February 27, 2014
RC-14-0030

Subject: VIRGIL C. SUMMER NUCLEAR STATION (VCSNS) UNIT 1
DOCKET NO. 50-395
OPERATING LICENSE NO. NPF-12
SOUTH CAROLINA ELECTRIC & GAS COMPANY'S SECOND SIX-MONTH
STATUS REPORT IN RESPONSE TO MARCH 12, 2012 COMMISSION ORDER
MODIFYING LICENSES WITH REGARD TO REQUIREMENTS FOR
MITIGATION STRATEGIES FOR BEYOND-DESIGN-BASIS EXTERNAL
EVENTS (ORDER NUMBER EA-12-049) (TAC NO. MF2338)

Attachment I SCE&G's Second Six Month Status Report for the Implementation of Order EA-12-049, Order Modifying Licenses with Regard to Requirements for Mitigation Strategies for Beyond-Design-Basis External Events

Attachment II Conceptual Sketches of Strategies

Figure 13 – FLEX Off-Site Response Map

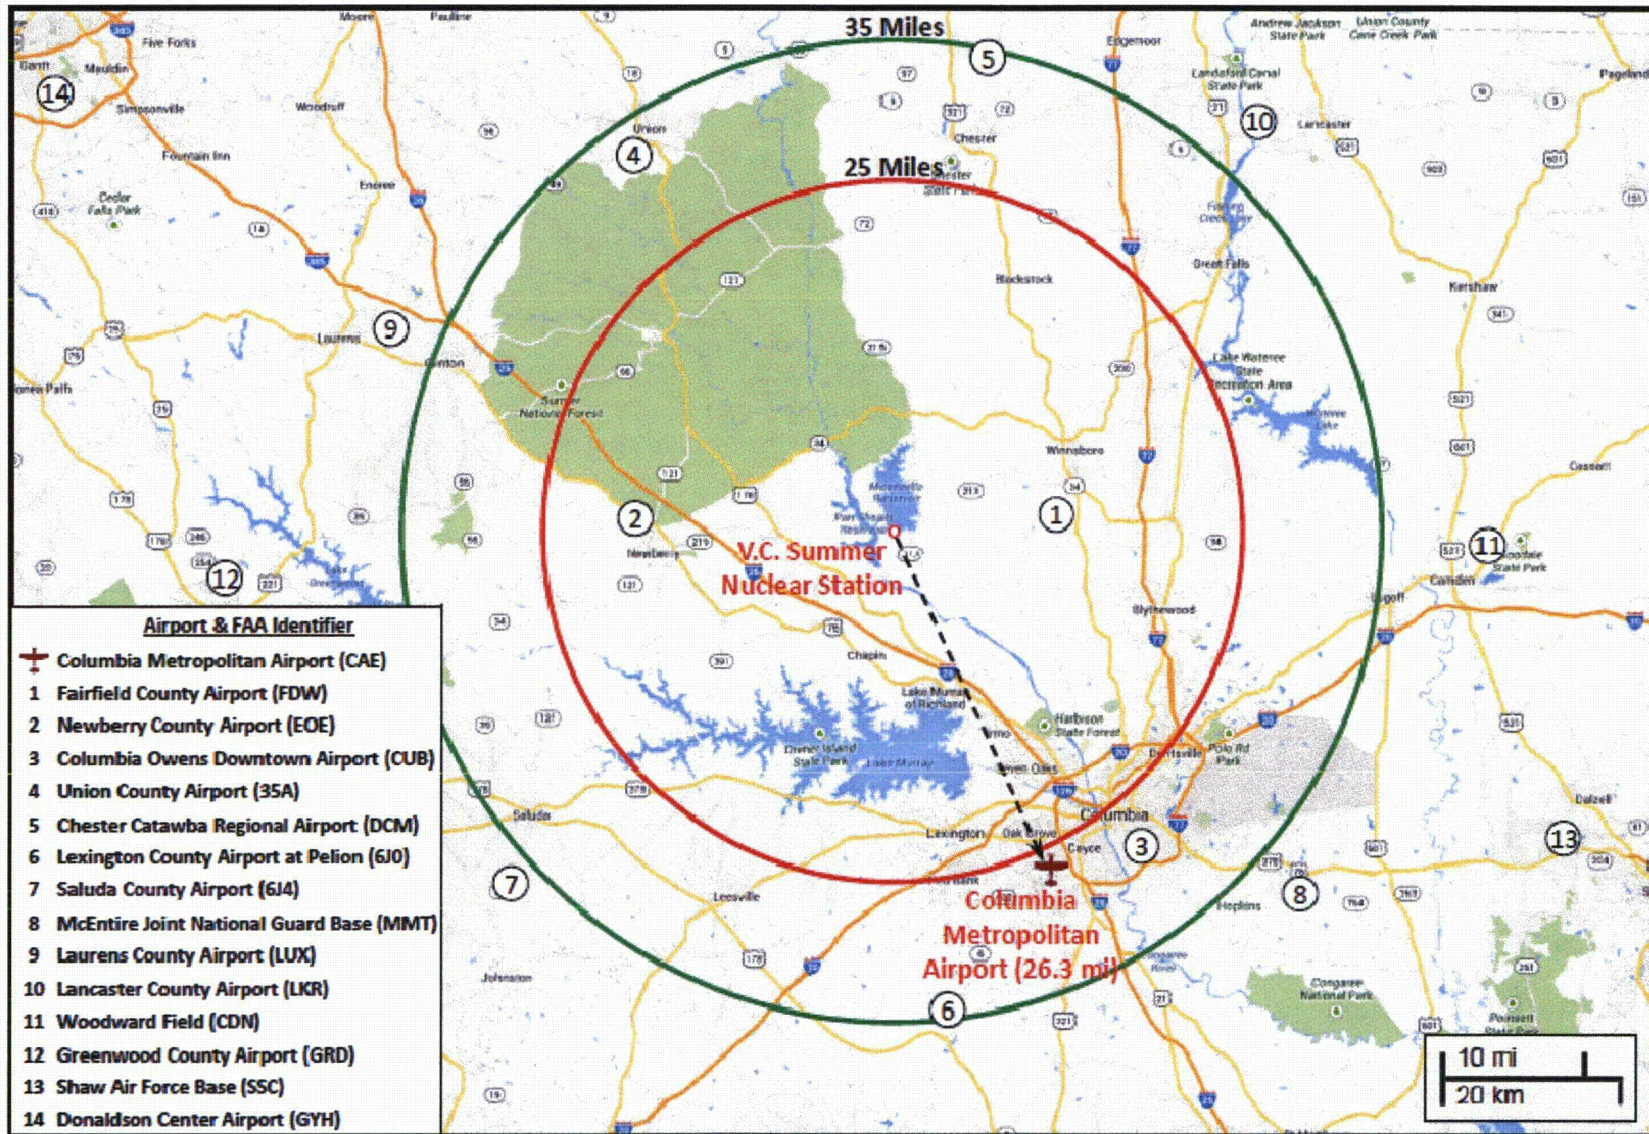
9A: A new paragraph was added to provide additional details regarding the transportation of Regional Response Center (RRC) equipment from offsite to the onsite staging area. Two new figures were added and referenced to provide regional and site specific views of the staging areas.

Figure 13 – FLEX Off-Site Response Map was added in Attachment II of this submittal to provide a regional view of the area with major roads, local airports, and the off-site staging area.
